Procurement Department Bid Section

ADDENDUM NUMBER: FOUR (4)

TITLE: 1412020648 (IFB) Brandy Branch Generating Station B52-B53 SCR Catalyst Replacement

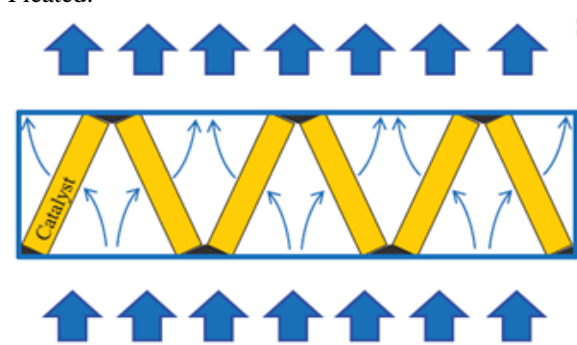
1. **Change:** The bid due date has been extended to **September 23, 2025**.
2. **Question:** In the RFQ the customer states that a low dp pleated or staggered module design is preferred. Umicore only provides a flat layer design. We don't offer a pleated and I'm not really sure what is meant by the term staggered design. If Umicore can not provide a pleated design, should Umicore believe that our flat layer design has a reasonable chance of being selected?

Answer: Staggered:

Pleated:

The objective is to reduce the gas side dP yet maintain similar performance.
